© 2013 la terra studio, inc. All Rights Reserved FILE:P:\12024-Downtown Rockwall PSS&E - Rockwall\CAD\SSHEETS\12024\_Enlargement\_Plan\_key.dwg

Enlargement Plan  
sheet number

**EP-3**

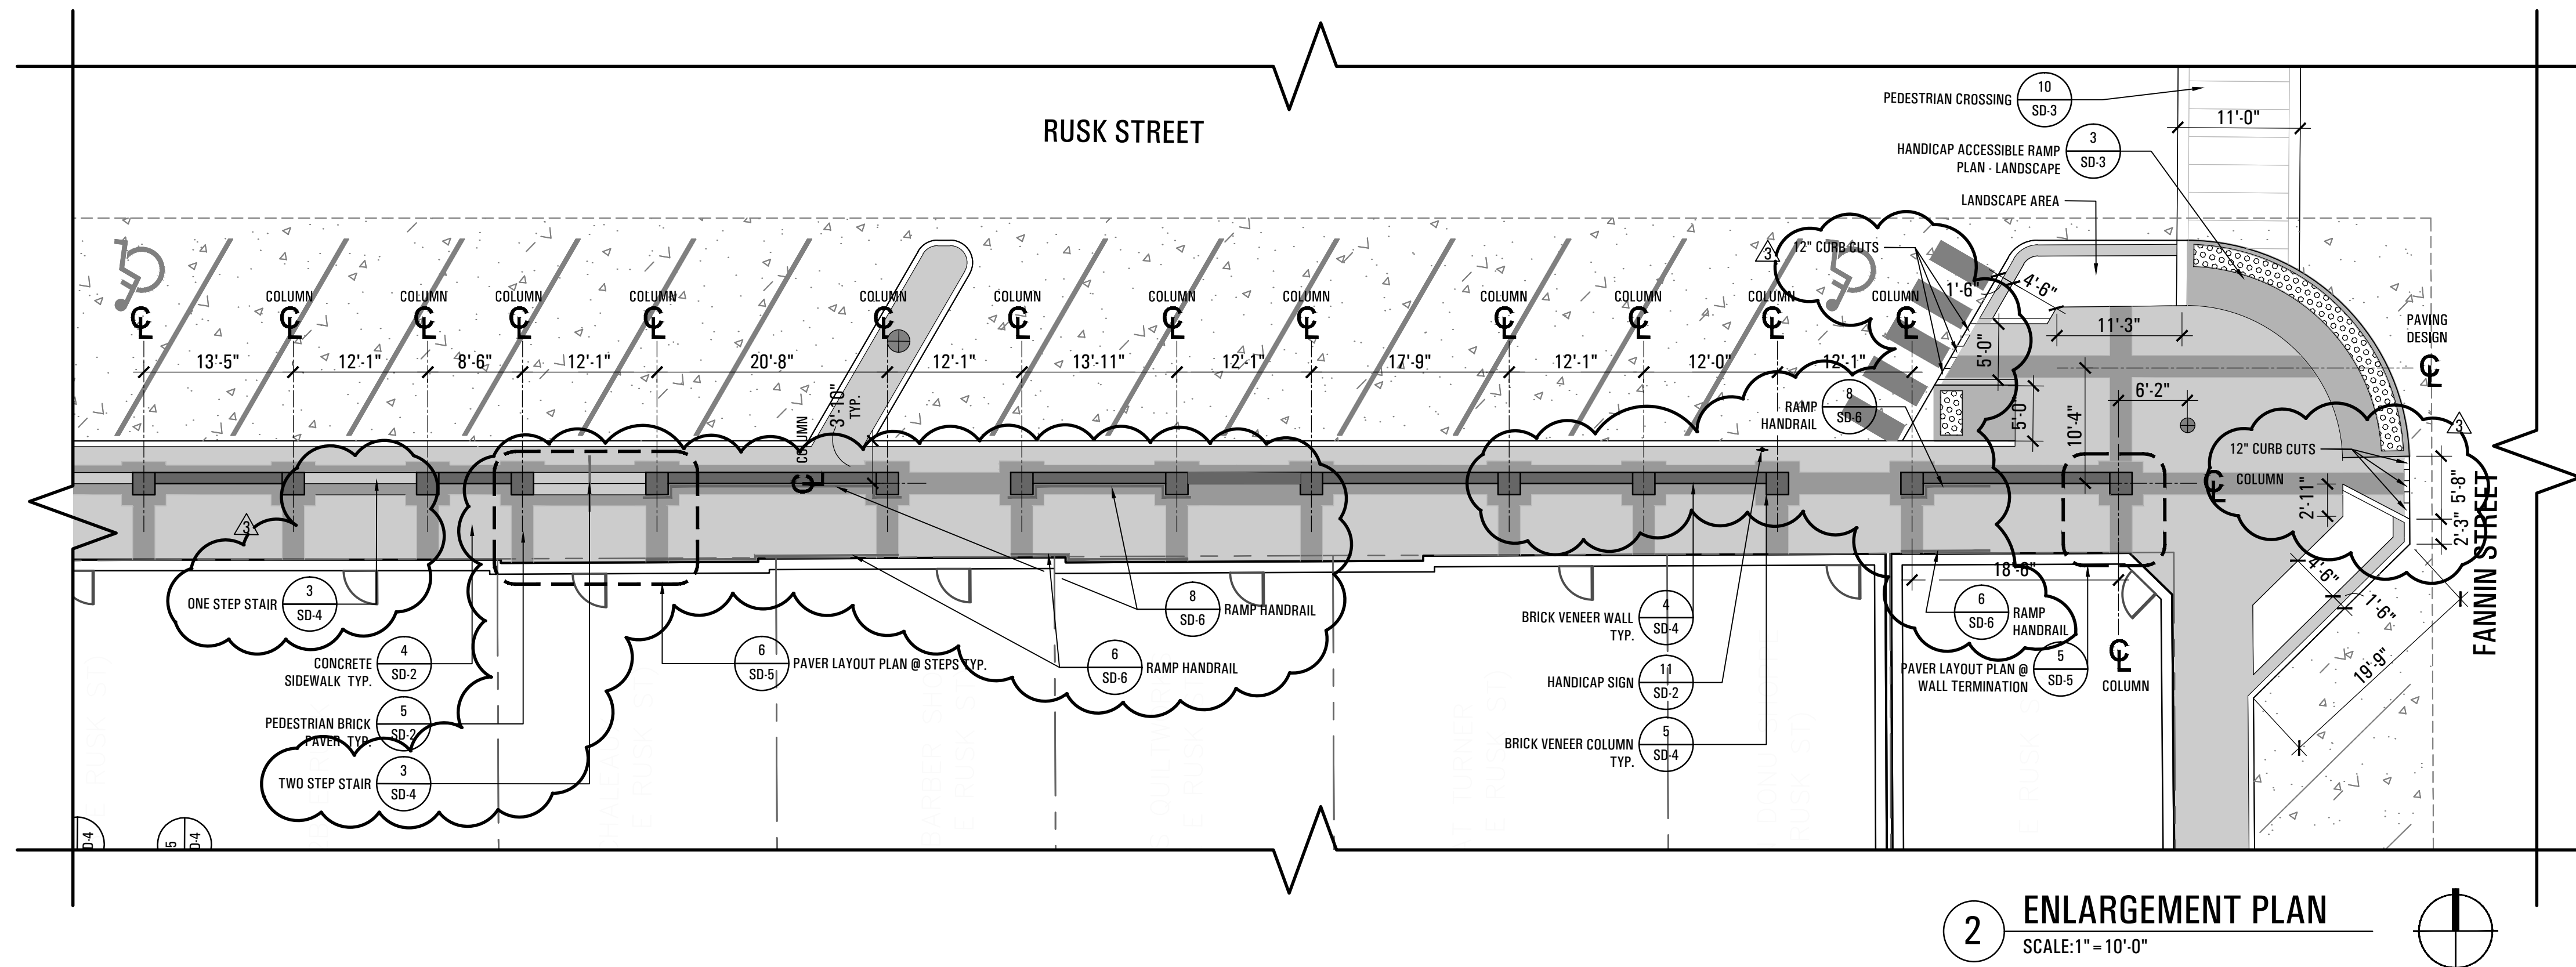
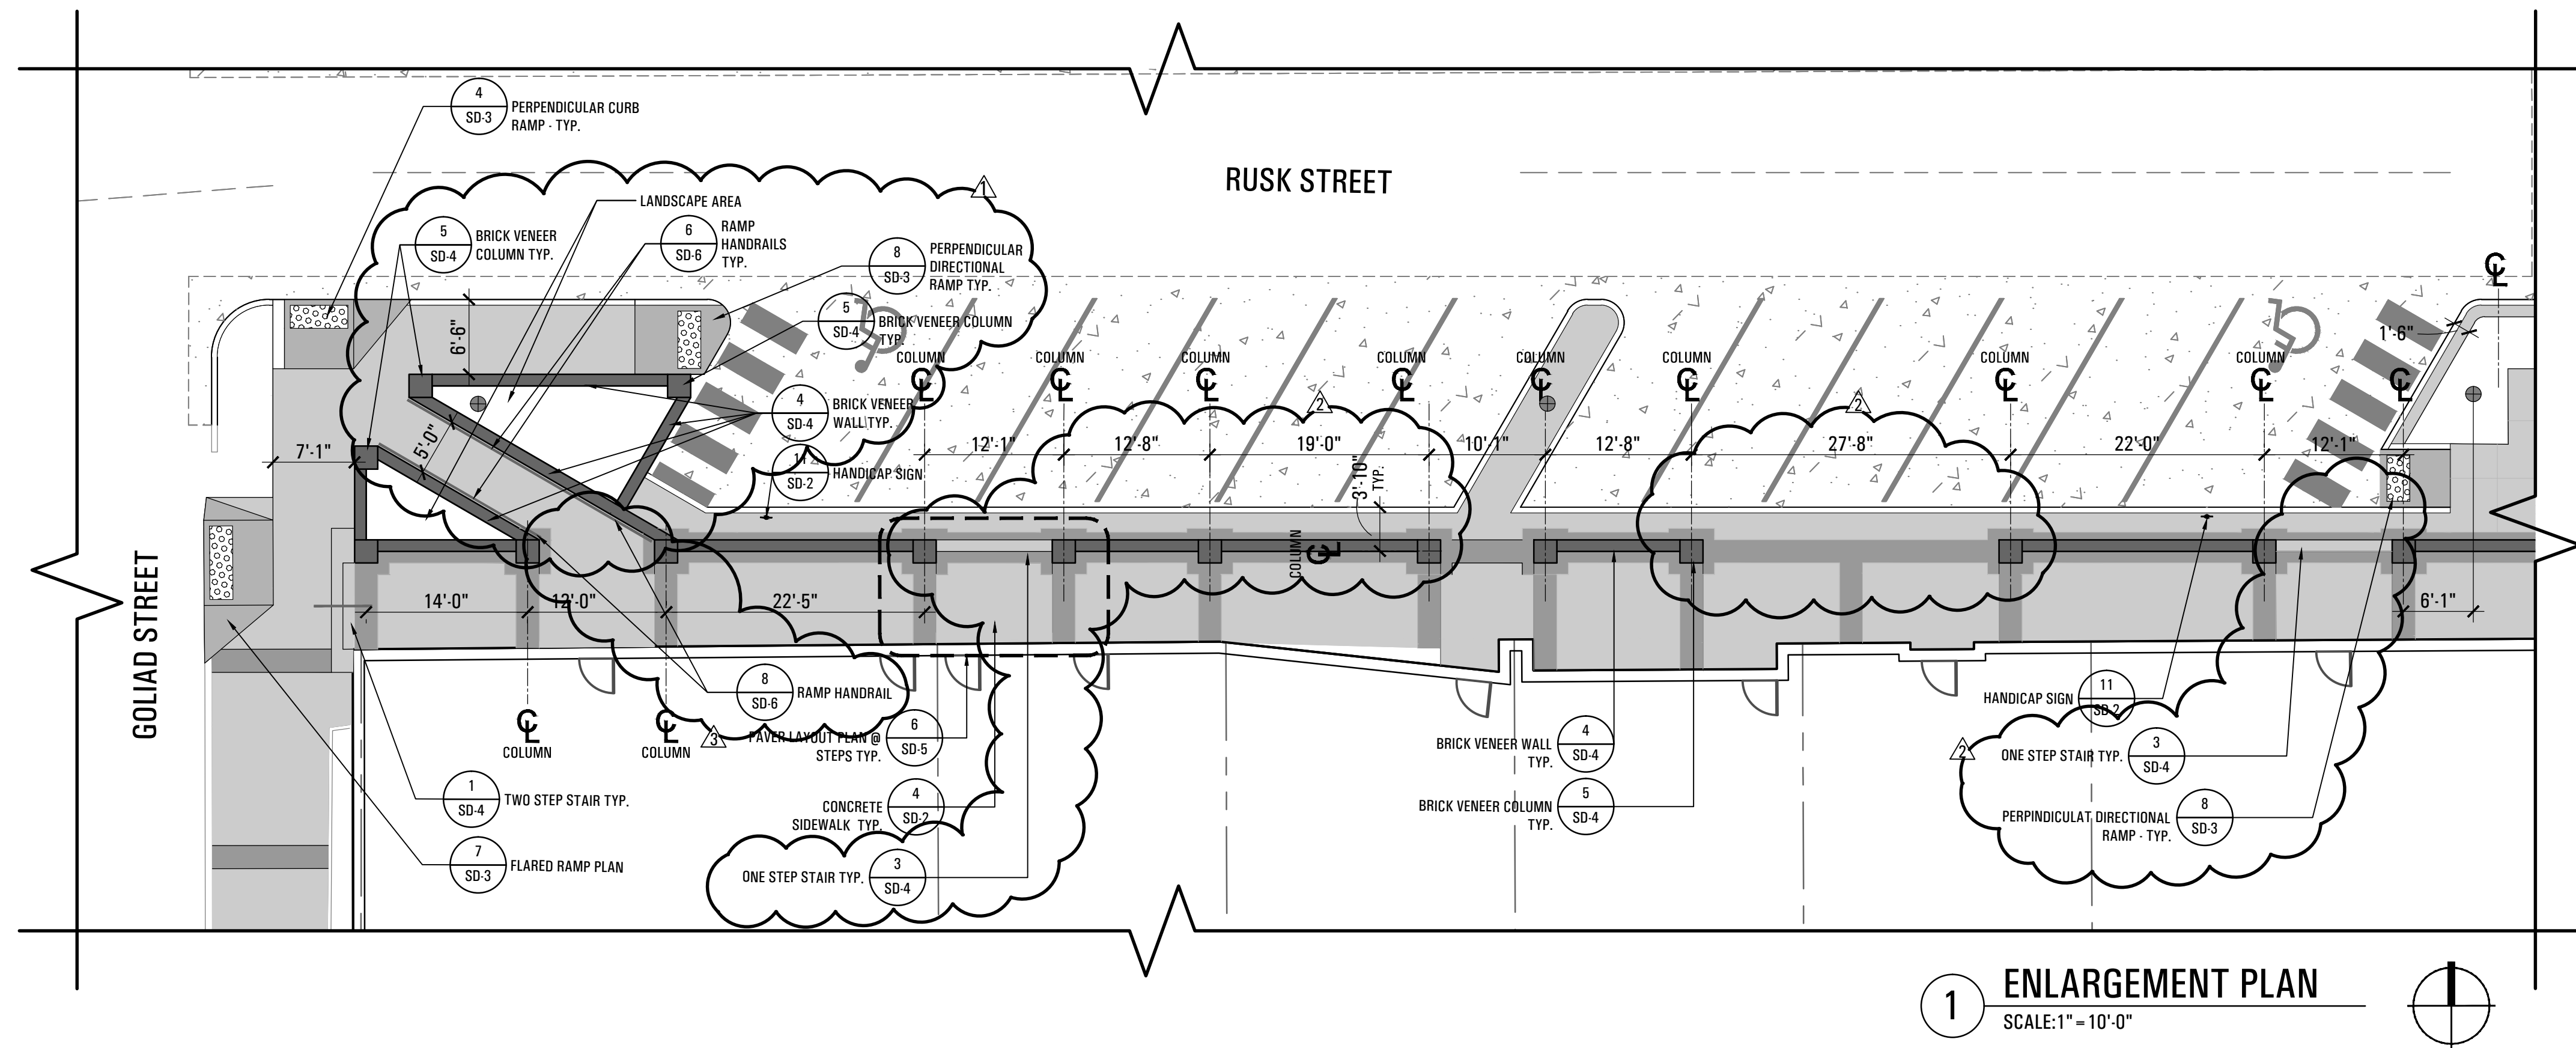
no.	date	detail
△	04/14/14	RFI #39
△	05/02/14	RFI #77 WEST RUSK GRADING
△	05/08/14	RFI #20, #38, #42, #43, #54
